61 Preble Street
Major Site Plan Application
PL-003222-2025
60 Elm Street LLC, Applicant

Submitted to:	Portland Planning Board	Prepared By:	Taylor Colbeth
Public Hearing Date:	June 24, 2025	Date:	June 20, 2025

Subject: 61 Cumberland Avenue – Major Site Plan Review
Zone: B3
Date of June 12, 2025
Review: Design Review – First Round Comments
Reviewer(s): Taylor Colbeth (Planner), Zach Powell (Senior Planner), Sean King (Urban Designer)
Project ID: PL-003222-2025

C-40

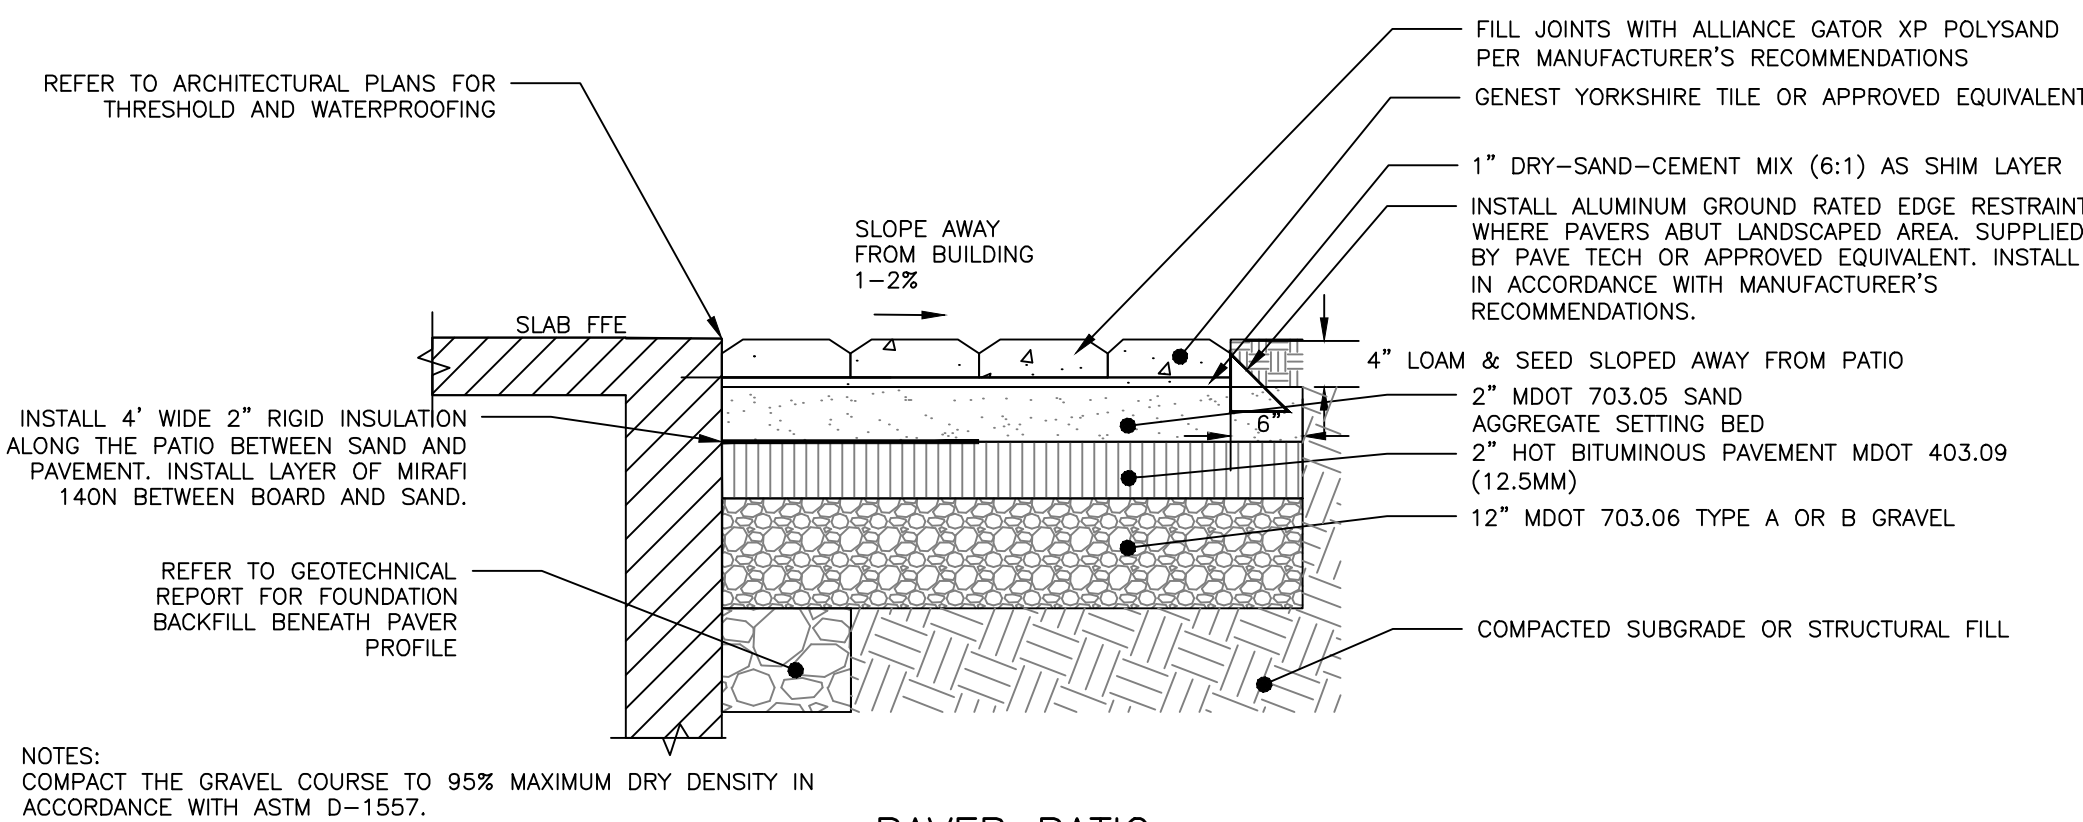
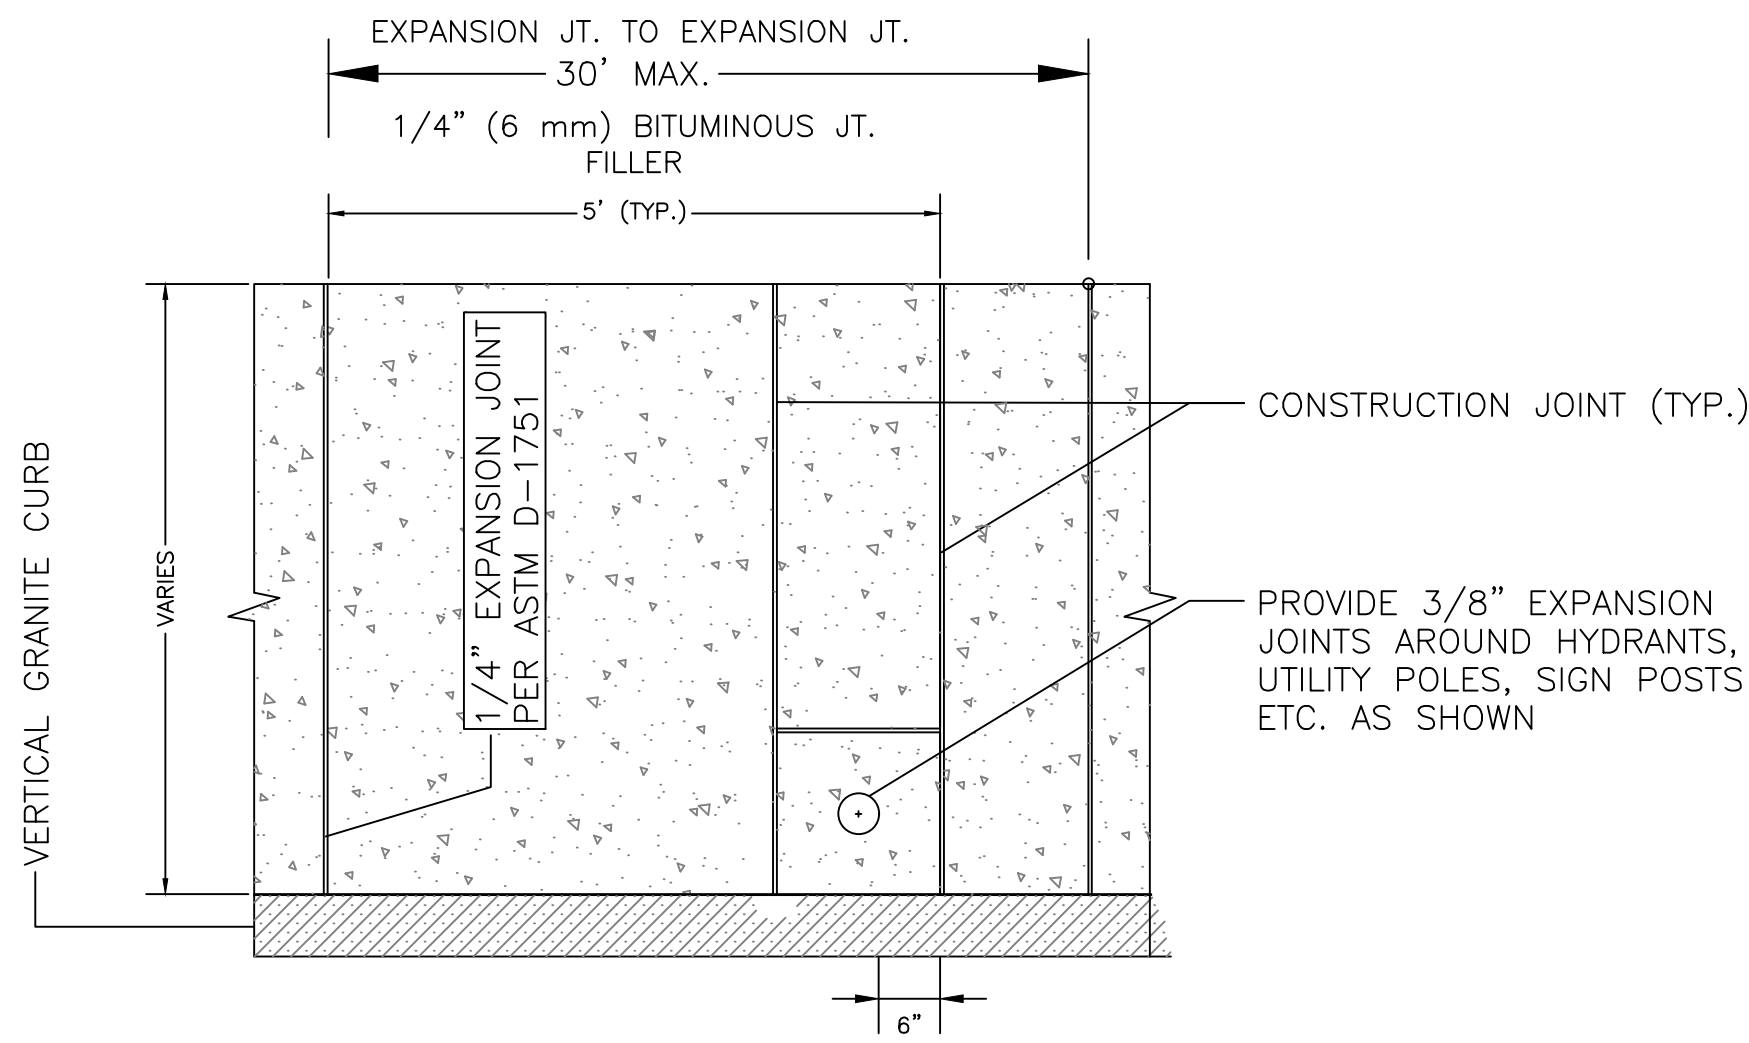
- *The applicant shall clarify what the slipform curb detail being used for in this project on Sheet C-40.*
